SUBJECT: LIMITING RELATIONSHIP BETWEEN CORE POWER AND CORE FLOW RATE
(TAC E3532)

Re: Nine Mile Point Nuclear Station, Unit No. 1

Amendment No. 92
License No. DPR-63

SAFETY EVALUATION BY THE OFFICE OF NUCLEAR REACTOR REGULATION
SUPPORTING AMENDMENT NO. 92 TO FACILITY OPERATING LICENSE NO. DPR-63

FIGURE 2.1.1 FLOW BIASED SCRAM AND APRM ROD BLOCK

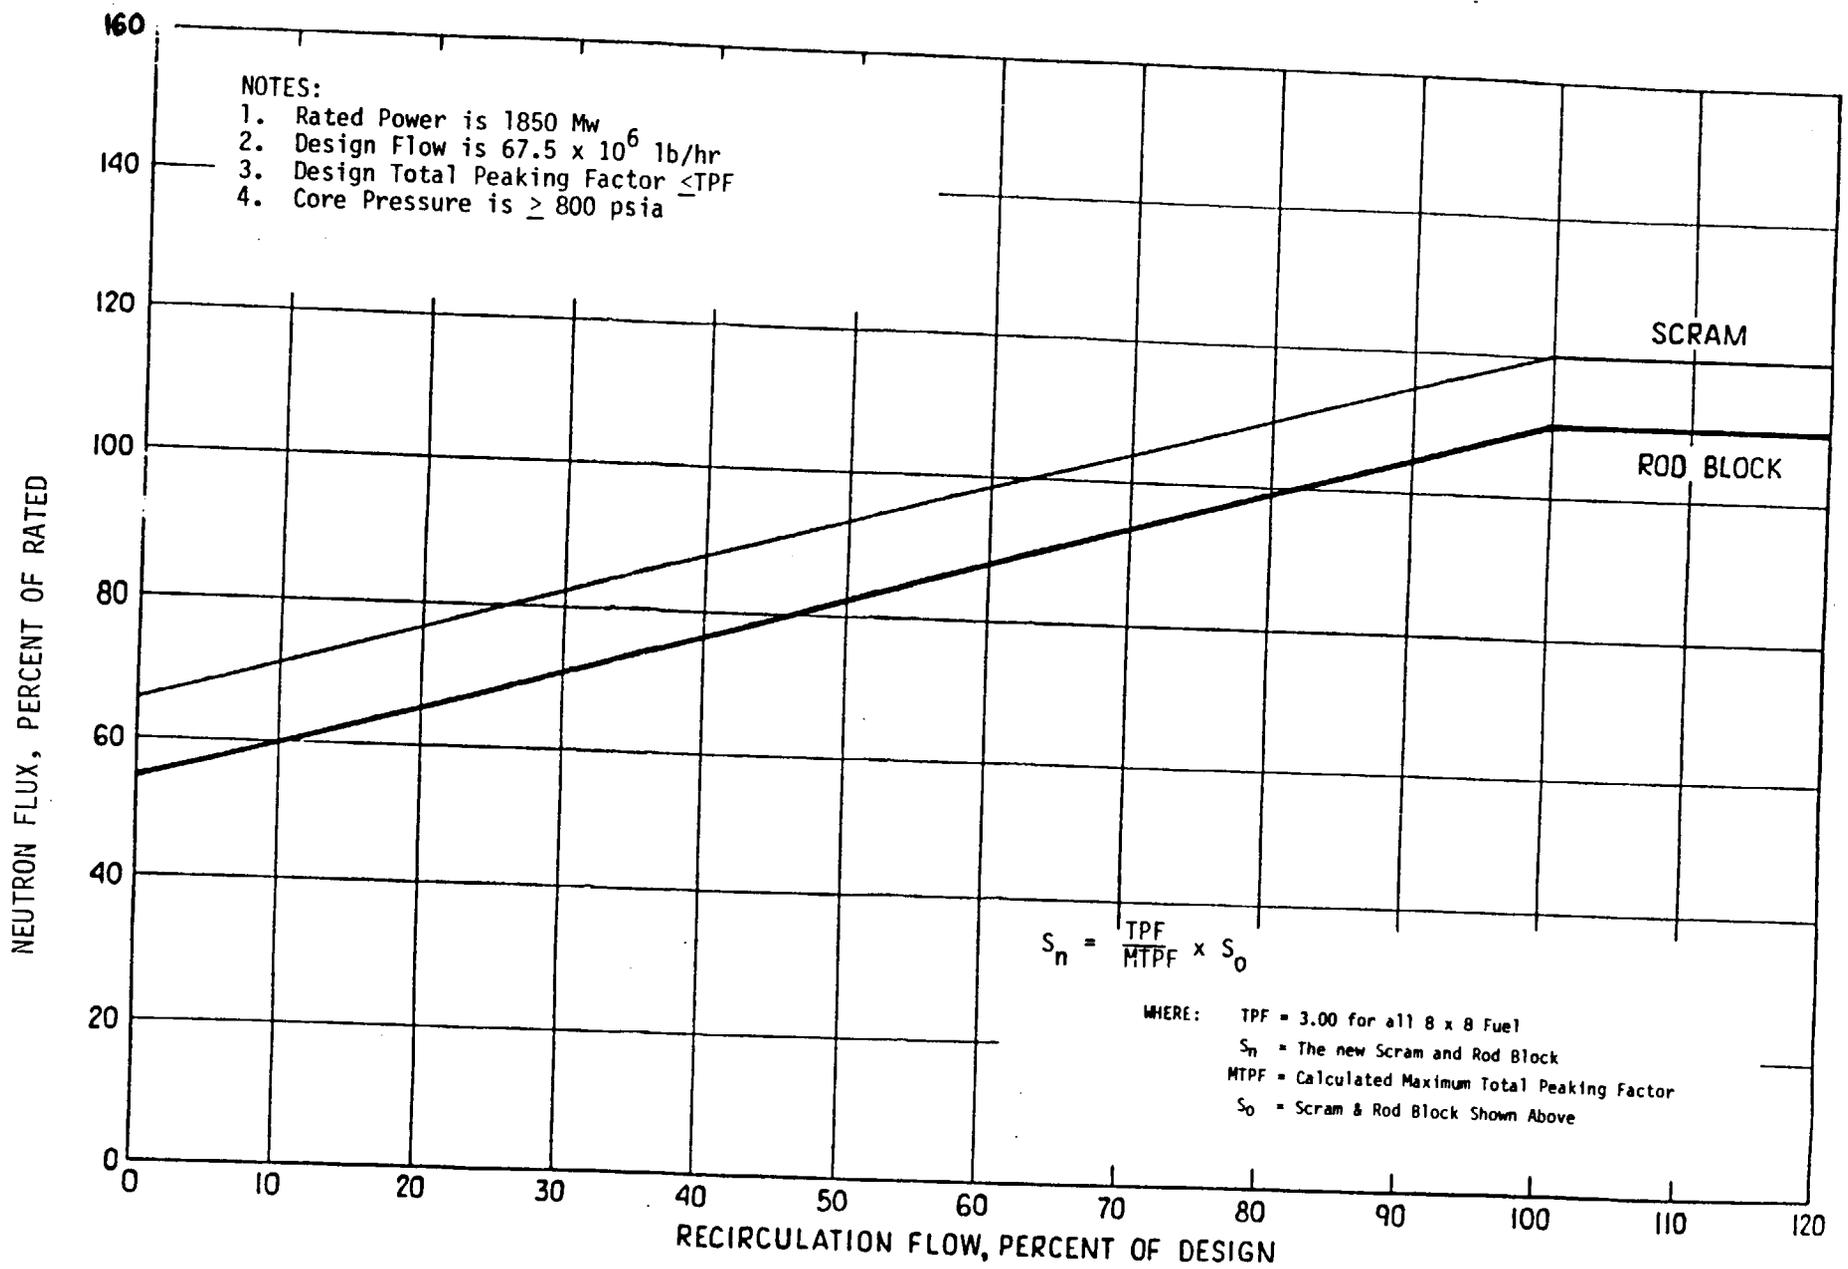
The amendment modifies Figures 2.1.1 and 3.1.7aa of the Appendix A Technical Specifications (TS) regarding the limiting relationships between core power and core flow rate. Specifically, the changes to Figures 2.1.1 and 3.1.7aa reflect changes to: (1) reduce a restriction on the reactor operating range and (2) provide consistency with the current reload analyses for the present Nine Mile Point Unit 1 core configuration and parameters.

Presently, the NMP-1 TS limit full power operation to the flow range from 91% to 100%. The Extended Load Line Limit Analysis (ELLLA) provides the basis for reactor operation in the region bounded by the 108% average power range monitor (APRM) rod block line (See Figure 2.1.1) and the licensee power. The present Power/Flow line was reviewed and approved in the Staff's Safety Evaluation supporting Amendment No. 36 to Facility Operating License No. DPR-63 dated March 29, 1980. The requested change affects a relatively small triangular area of the Power/Flow Map for core power between 85 and 100% and core flow between 61 and 91%. A GE safety analysis (NEDC-31126, February 1986) was performed to demonstrate that the consequences of transients and accidents initiated from within the expanded ELLLA region are bounded by the consequences of the same events initiated from the licensing basis condition for NMP-1, Cycle 9. Consideration was also given to overpressure protection for compliance with the American Society of Mechanical Engineers (ASME) Pressure Vessel Code, and reactor core thermal-hydraulic stability.

Based on our review of the anticipated changes in core behavior, we conclude that the proposed changes correctly address the proposed extended operating region and are, therefore, acceptable. The revised figures reflect the new flow-biased scram and APRM rod block settings and the limiting power flow line. No changes to the present TS operating limit Minimum Critical Power Ratio or MAPLHGR limits are required.

Figure 3.1.7.a a LIMITING POWER FLOW LINE

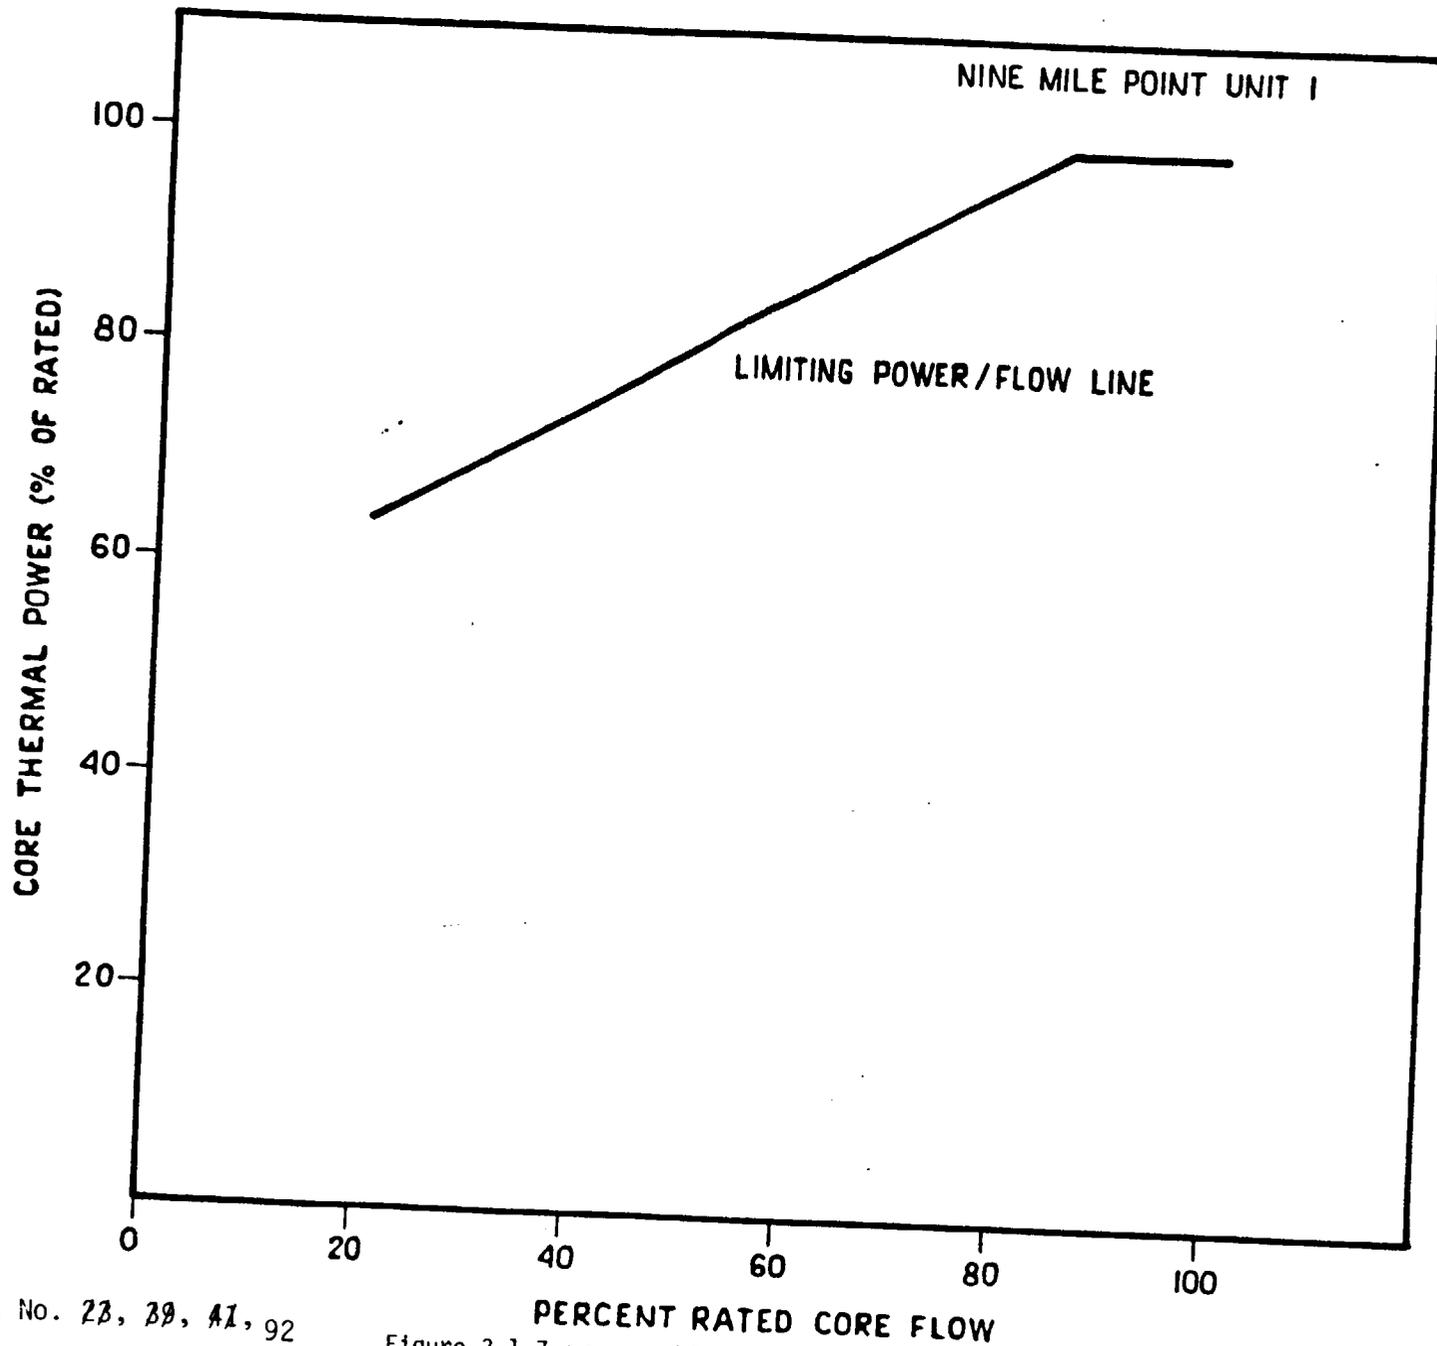
By application dated October 30, 1986, as supplemented January 15, 1987, Niagara Mohawk Power Corporation (the licensee) requested an amendment to Appendix A of Facility Operating License No. DPR-63 for the Nine Mile Point Nuclear Station, Unit No. 1 (NMP-1). The amendment would modify Figures 2.1.1 and 3.1.7.aa in the Appendix A Technical Specifications (TS) regarding the limiting relationships between core power and core flow rate. Specifically, the changes to Figures 2.1.1 and 3.1.7aa would reflect changes to: (1) reduce a restriction on the reactor operating range, and (2) provide consistency with the current reload analyses for the present Nine Mile Point Unit 1 core configuration and parameters. In support of the proposed modification, the licensee provided General Electric Company (GE) Report, NEDC-31126, "General Electric Boiling Water Reactor Extended Load Line Limit Analysis for Nine Mile Point 1 Cycle 9" dated February 1986.
